FG/85/15/PL

PLAN-009988

Proposal: Demolition of three buildings & erection of replacement workshop & machinery store (amended to FG/161/14/PL).

Site: Onslow Caravan Park, Onslow Drive, Ferring, BN12 5RX.
FG/85/15/PL

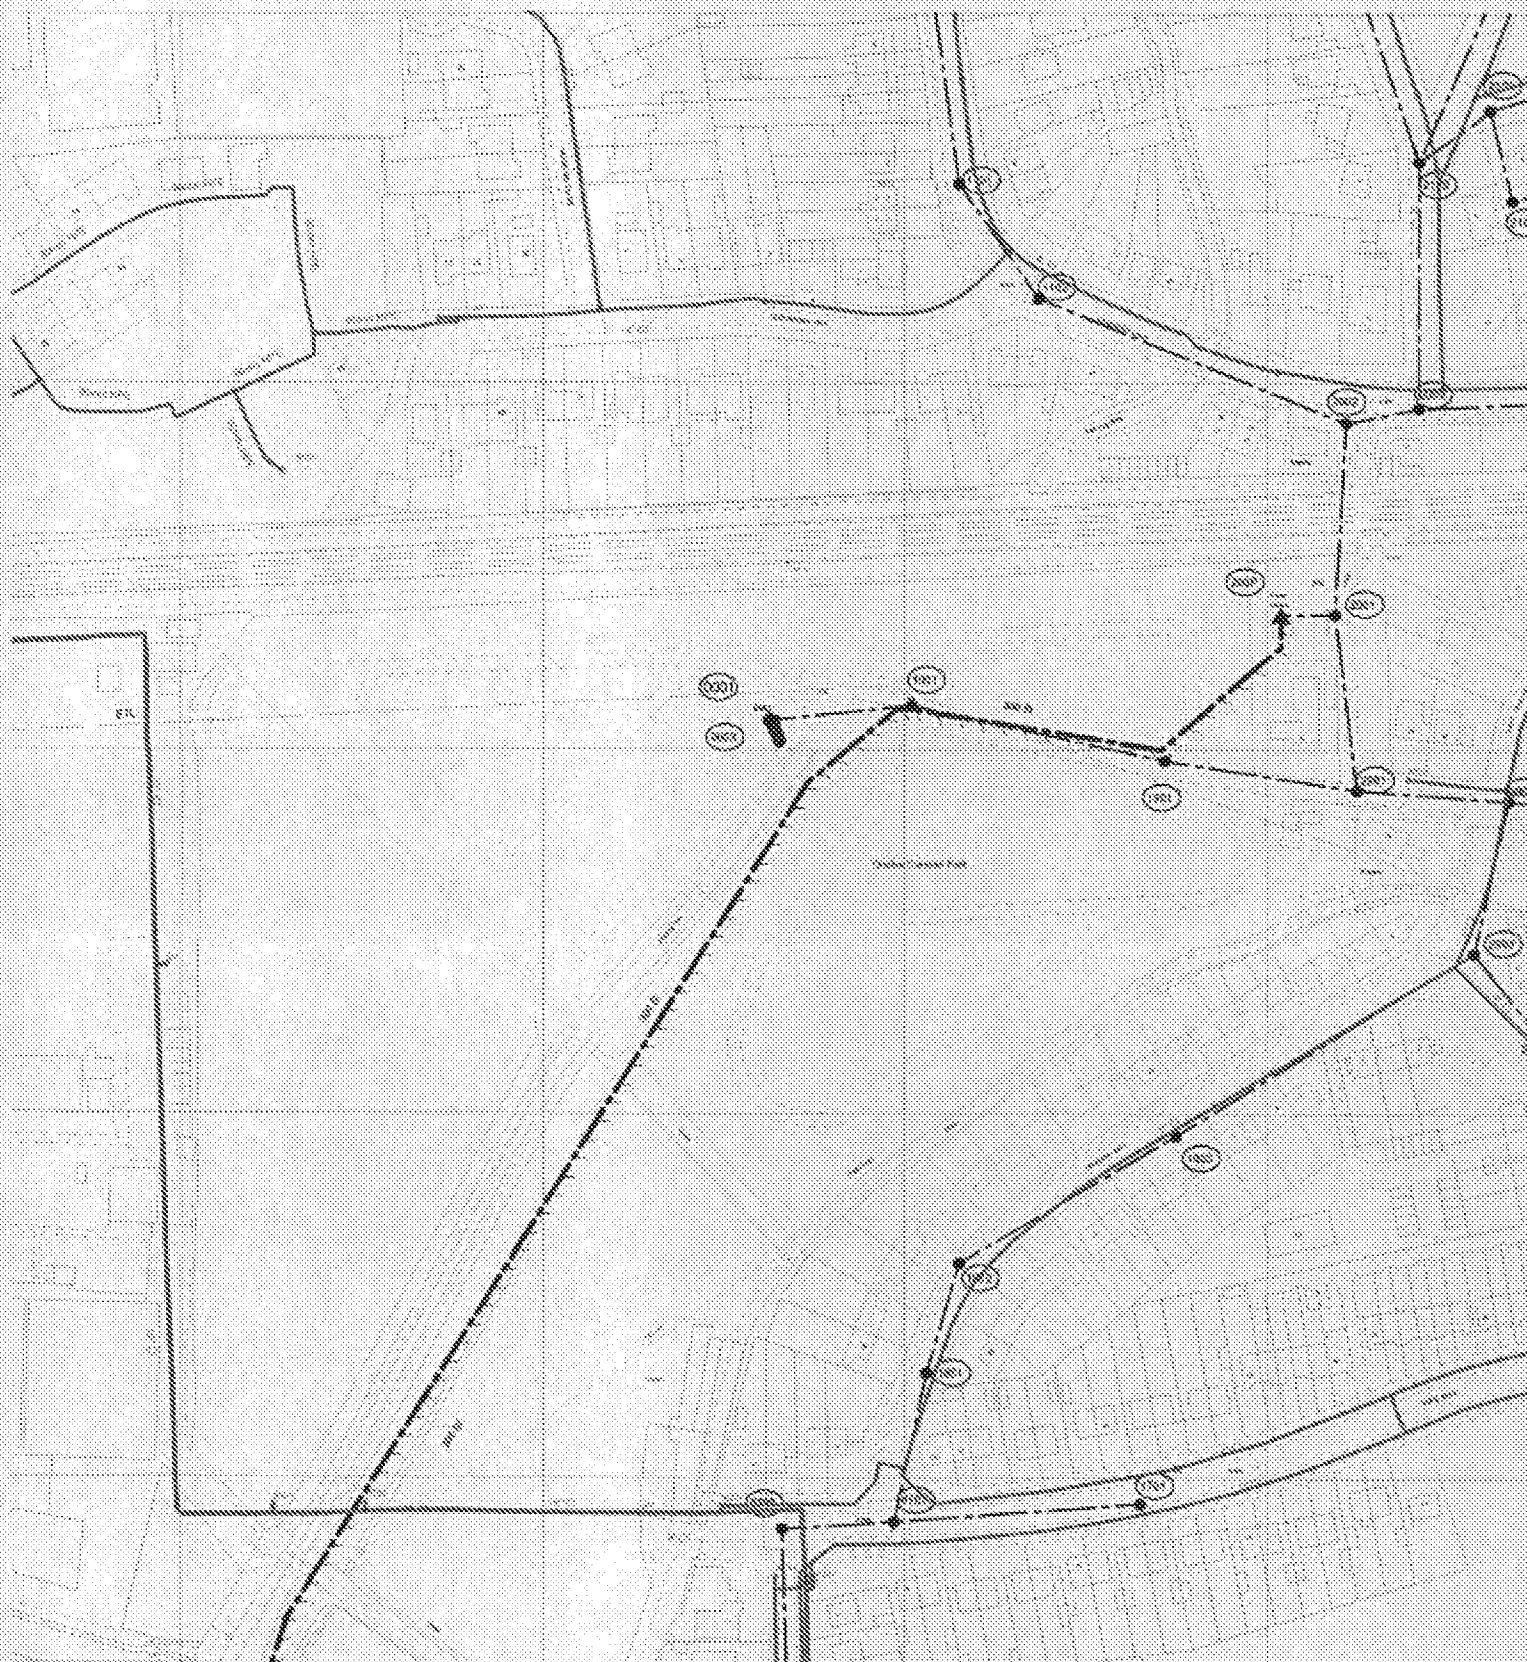
Please find attached a plan of the sewer records showing the approximate position of foul rising main and foul sewer within the site. The exact position of the foul rising main and foul sewer must be determined on site by the applicant before the layout of the proposed development is finalised.

- No development or new tree planting should be located within 3 metres either side of the centreline of the foul rising main and foul sewer.
- No new soakaways should be located within 5 metres of a public sewer.
- All existing infrastructure should be protected during the course of construction works.
